Report to the Chief Officer (Highways and Transportation)

Date: 12 April 2016

Subject: Riverside Mills, Horsforth - Consent for new culvert

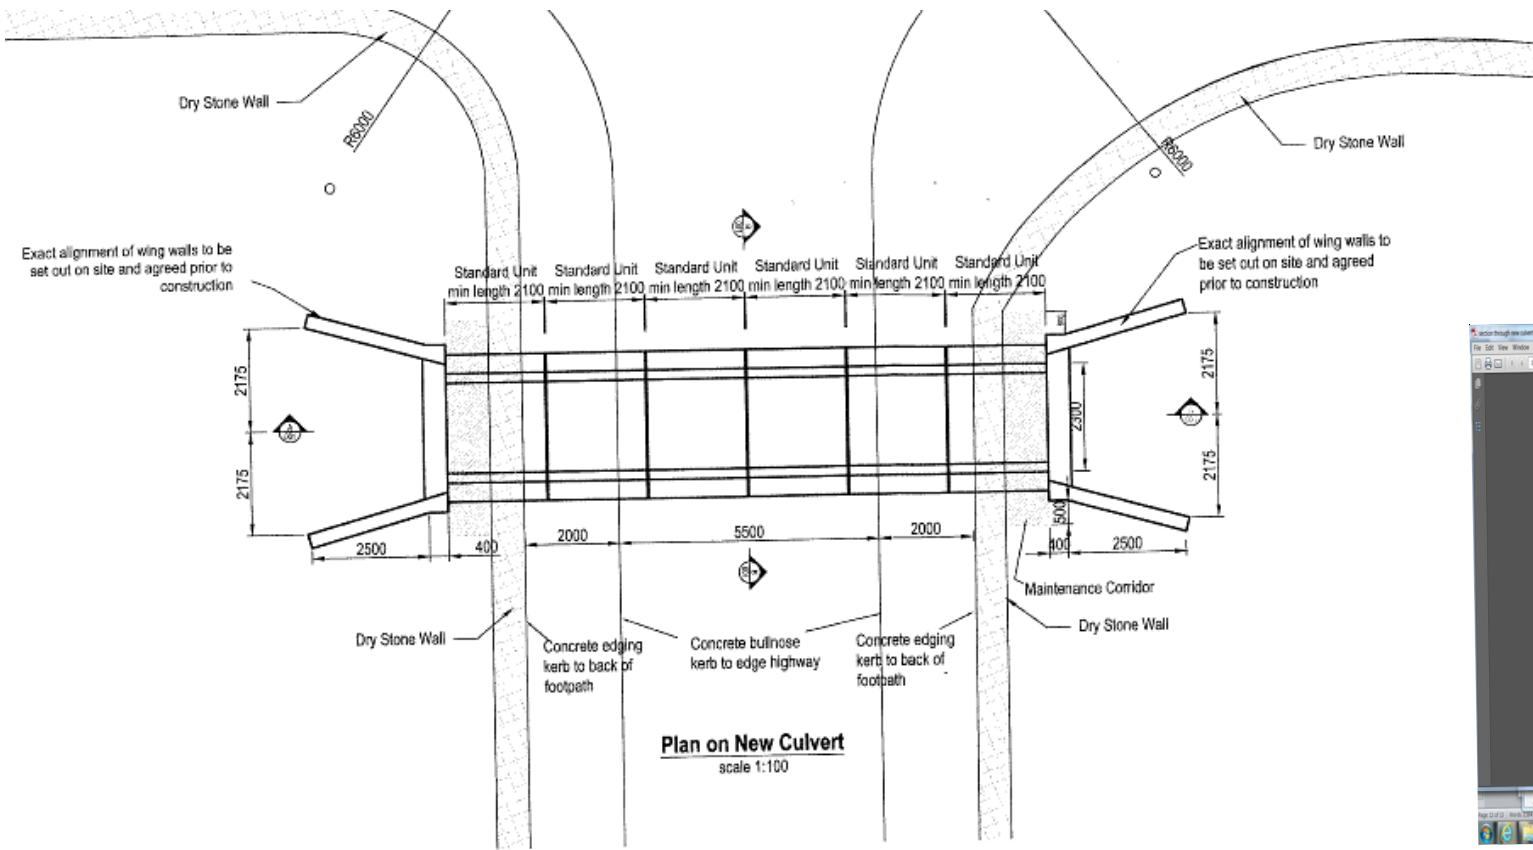
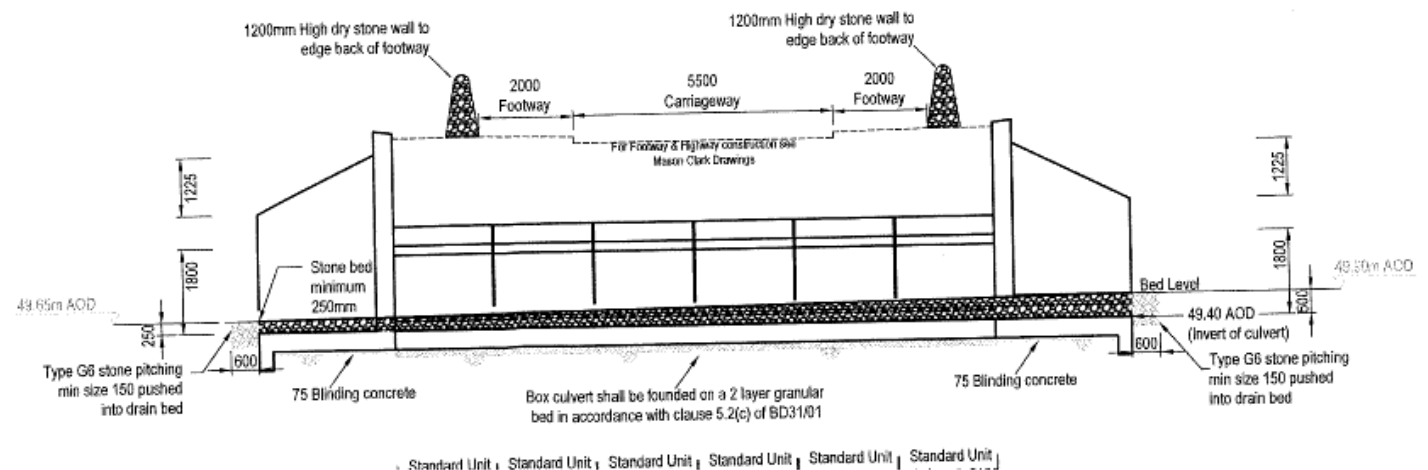
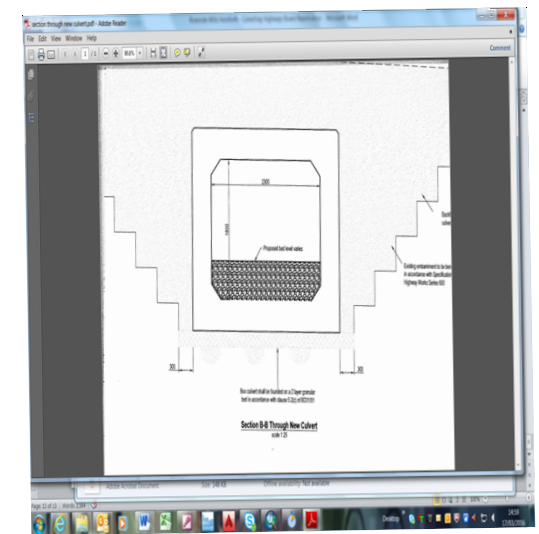
I have made comments on these works through condition discharge and recommended additional details/drawings submitted prior to discharge. Even though the sections to be modified are predominantly "unnatural" due to past works and therefore are acceptable in principle I am concerned that the terraced rows of gabion baskets that have been proposed for the new route of the Gill Beck will look unnatural.

We want to create an ecologically valuable and visually acceptable solution - in order to get some natural vegetation established on the top face of each terraced gabion there should be a reservoir of soil retained in a membrane with native ground flora planted (native ferns, sedges and ivy etc.). Additional planting for the top gabion where it meets the surrounding ground level should also be included to soften that interface.

No plans have yet been submitted to show how the gabions will be modified to soften them – can you include a condition along the lines of:

Prior to works commencing an Ecological Enhancement Scheme will be agreed with LCC to provide biodiversity features along the section of the Gill Beck to be re-routed. The Scheme will include appropriately scaled drawings with features for soil retention and planting proposals on each of the gabion basket surfaces. The Scheme will also include specifications for vegetation planting and maintenance.

- a) The works shall be carried out in accordance with the approved drawings: New Culvert – Proposed GA and Sections, Dwg No. 13682.001 – rev P3. Any amendments to the approved drawings will be subject to approval by Council’s Flood Risk Management (FRM) section;
